Nant Mithil Energy Park, Powys.
PEDW DNS Application Ref: DNS CAS-01907-D7Q6Z1.

CPRW-RE-think Chapter 4 on
Landscape and Visual Amenity

Evidence by CPRW-RE-think on:
Landscape and Visual Amenity.

This chapter discusses the Landscape and Visual Impact Assessment produced by LUC and identifies the principle significant adverse landscape and visual effects.

Figure 6: Viewpoint 7 – Dolau – Existing View

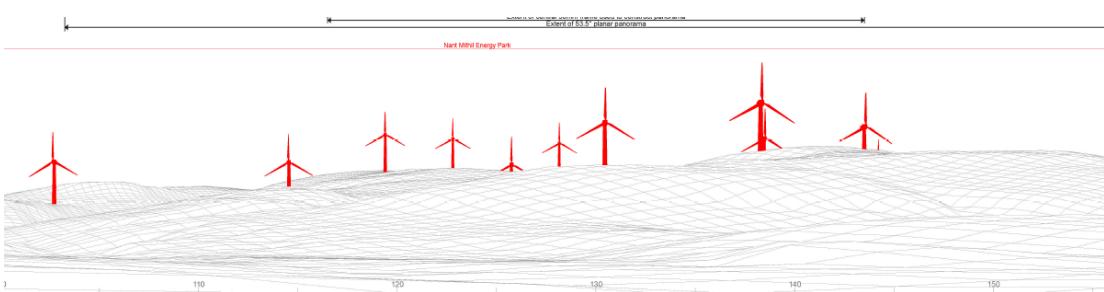
The proposed development would be visible across the full extent of the skyline from this viewpoint (see Figure 7). A total of 13 turbines would be visible to hub height (extending beyond the panorama within Figure 7), with many visible from base to tip, appearing physically connected to the immediate landscape due to the lack of significant topographical screening. Ground level at the viewpoint is approximately 242m AOD, with Great Rhos rising to 418m AOD, meaning that turbines would occupy more than half of the apparent hill height. Overall, the broad lateral spread of the development, its dominance over the key focal hills, and its influence on both landscape pattern and vertical relief would result in *High* levels of effect from this viewpoint (contrary to the assessment of *Low*), equating to **Major** effects rather than *Minor*.

Figure 8: Viewpoint 23 – Offa’s Dyke, Castle Ring Pen Offa – Existing View

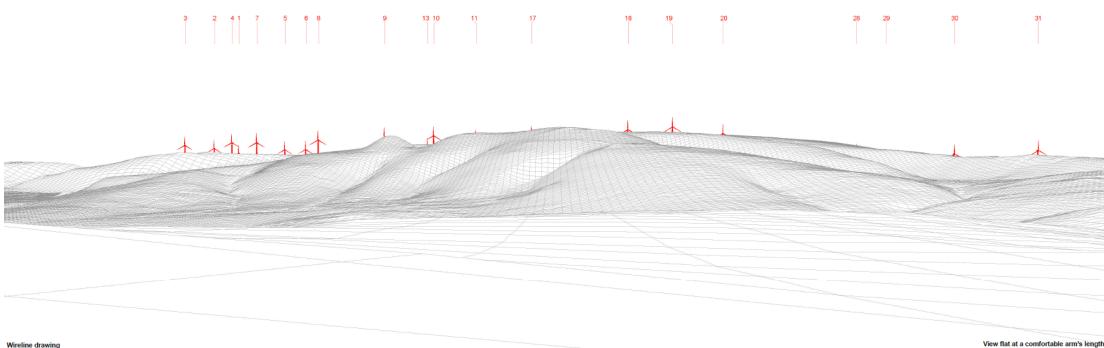
The proposed development would be visible across much of the Radnor Forest hillsides, with twelve turbines clearly visible to hub height and a further two likely to be perceptible in winter when woodland cover reduces (see Figure 9). The turbines would be positioned behind and adjacent to the form of The Wimble, interacting with and partly displacing this existing visual focus, with turbine heights broadly matching the vertical scale of the landform. The proposals would therefore introduce a clear and noticeable change within the view, affecting a substantial portion of the principal focus. I judge the magnitude of change to be *Medium*, resulting in ***Moderate-Major*** effects, rather than the *Minor-Moderate* level set out in the LVI.

Figure 10: Property 20 - The Mountain: Existing View A, South-east

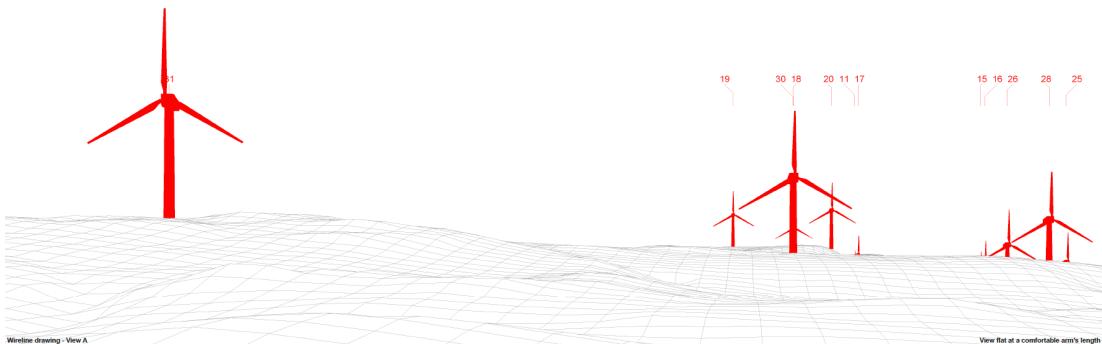
The Proposed Development will be visible within the hillsides facing the property, at a distance of 1.01km from the nearest turbine. Due to the elevated location of the property, the proposed development will appear to sit within adjacent landscape, with little separation and at only 106m additional height gain. A total of 14 hubs will be visible, the closest turbine being T31, siting within the open ground, visible from base to tip and appearing large against the smaller scaled landscape, individual trees and field patterning. Views to the south-east (see Figures 10 and 11) are gained from the front of the property, from outdoor seating and first floor bedrooms. These views are also attained when moving along the access track to the house, with a defining impact upon the property and its setting. The proposed development will extend across the entirety of the skyline, with fundamental changes to the view, dominance of scale against the height of the hill and adjacent features and overwhelming presence for residents of this property.

Figure 12: Property 20 - The Mountain: Existing View B, South-west

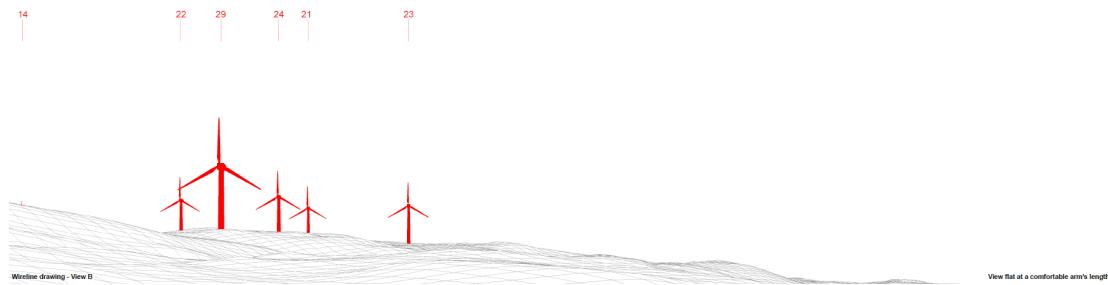
Views to the south-west (see Figures 12 and 13) are experienced from the front of the property, as a direct continuation of the south-east panorama. This view is also a focus from the garden to the west side of the property, with channelled views to the western turbine group. Turbines within this angle of view appear more distant, without the strong connection to the immediate landscape of the south-east views. However, they remain a dominant feature, altering the balance of the view and creating a broad lateral extent of development within the overall view. Issues of scale are again apparent within this view, with turbine 29 in particular, altering perceptions of height for the further hillside, appearing at large vertical scale against the small hill form below and incongruous in size against the farmsteads to the fore. Lack of setback against the smaller scale landscape is indicated within these scaling issues.

Overall, the development will present a dominating presence within the setting and upper floor views of the property. It is judged that the proposed development will form an inescapable presence within views from the access track, curtilage and first floor rooms. The lack of separation results in the appearance of attachment to the immediate landscape of the property, within the open fields of the landscape within the key views. These factors of determined to result in **overbearing effects** for this property.
